Substantive response of the Local Highway Authority to a planning consultation received under The Development Management Order.

Planning Application Number: 25/00199/FUL

Application Address: Land Adjacent 232 Ashby Road Hinckley Leicestershire

Description of Application: Erection of 25 dwellings, new access off Normandy Way, amenity space, parking and community orchard

Figure 1: Site Access.

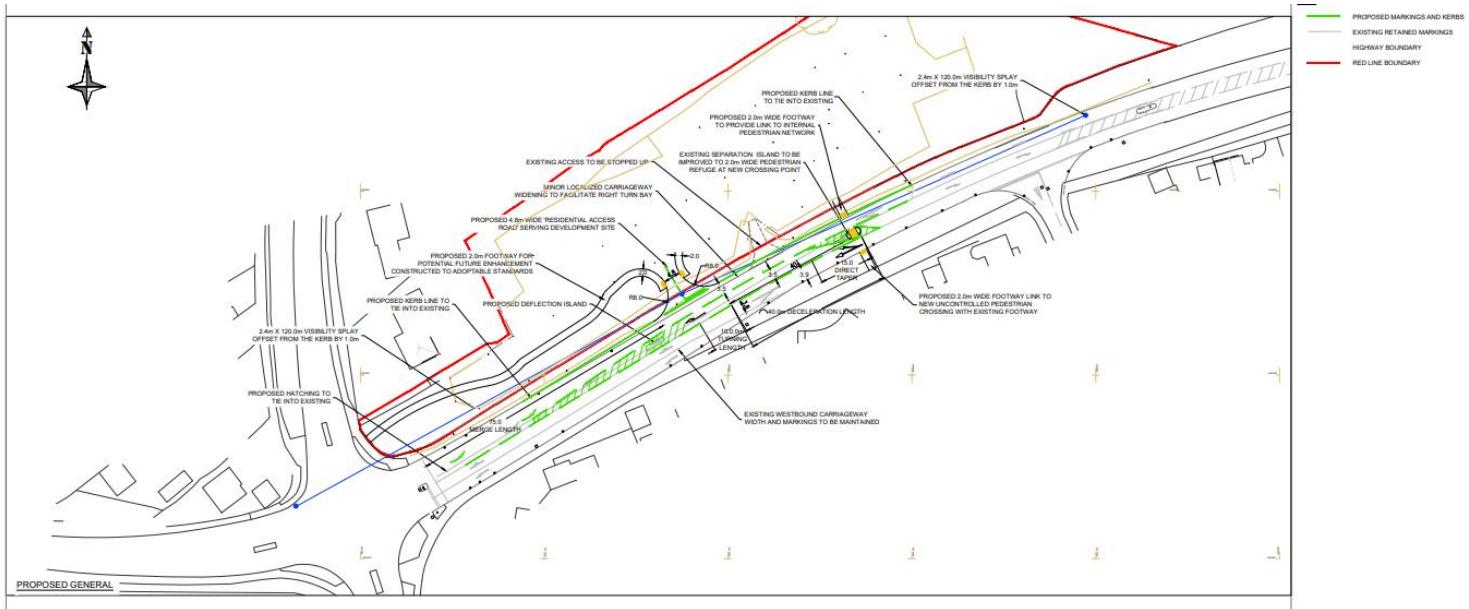
The drawing shows a merge length of 75m for eastbound traffic exiting the A47 Normandy Way/ A447 Ashby Road/ B4667 Ashby Road signalised junction. Design Manual for Roads and Bridges (DMRB) CD123, para. 7.12.1 states that where it is necessary to reduce the number of lanes on the exit arm, a single lane should be reduced over a distance of 100 metres starting at or beyond

The LHA advise that it has concerns in respect of reducing the merge length as this could result in a reduction in the level of traffic using the merging lane. Given existing capacity concerns at the junction, the reduction in the length of the merging lane could have implications on the operation and capacity of the junction should less drivers choose to use it.

That application identified that the junction would be operating over its capacity in the AM peak in 2026 with committed development in place, and that the proposed development would exacerbate the situation. Furthermore by 2032, capacity at the junction was forecast to have deteriorated further and to the point that it would operate overcapacity in both the AM and PM peaks with that proposed development in place. The proposed scheme would present a nil detriment solution for the trips generated by that development. Currently an alternative scheme is being investigated by Leicestershire County Council to accommodate the wider growth in the area, however the LHA advises the proposed development access could prejudice the delivery of either scheme, given the proximity of the site access to the existing junction and the requirement to reduce the length of the merging lane.

The LHA cannot see any reasonable way to resolve this concern as the site access could not be relocated further west towards the signalised junction and to relocate it further east would impact on the existing ghost right turn lane for the existing Cornwall Way estate.

Based on the recorded vehicle speeds referenced above and [Figure 6](#) of the LHDG, visibility splays of 2.4 x 120m would be required to the west of the site access and 2.4 x 73m to the east. The Applicant has shown visibility splays of 2.4 x 120m in each direction, which is considered acceptable to the LHA. Visibility would be achievable subject to the removal of the existing hedgerow along the site frontage between the site access and the A47 Normandy Way/ A447 Ashby Road/ B4667 Ashby Road signalised junction. This is proposed on BRP Architects drawing number M170-BRP-00-00-DR-A-0102 Rev. P02.

The 4.8m access width is in accordance with [Table 3](#) of the LHDG for the number of dwellings proposed. However, for the refuse lorry left and right turns out of development, the vehicle must use the entire width of the access to perform the manoeuvre. Vehicles turning left into the development would be forced to wait for the vehicle to exit which could result in traffic tailing back towards the signalised junction. Under the site-specific circumstances, the LHA advise an increased access width would be accepted so that opposing vehicles can pass one another.

DMRB CD123 para 5.6.3 requires corner radii of 15m with corner taper of 1 in 6 over 30m at ghost island junctions, the Applicant would therefore need to seek to implement this into the design.
